Clutch Pedal Squeak/Creak Noise

Service
Category Drivetrain

Section Clutch

The information contained in this bulletin supersedes SB No. TC004-06.

Figure 1.

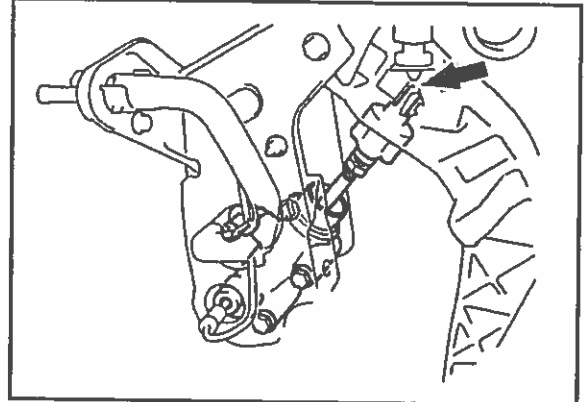
Be sure to apply MP Grease where the clutch master cylinder clevis and clutch pedal meet in addition to the locations identified in the Repair Manual (See Figure 1.)

2. Replace the clutch pedal and clutch master cylinder assembly.
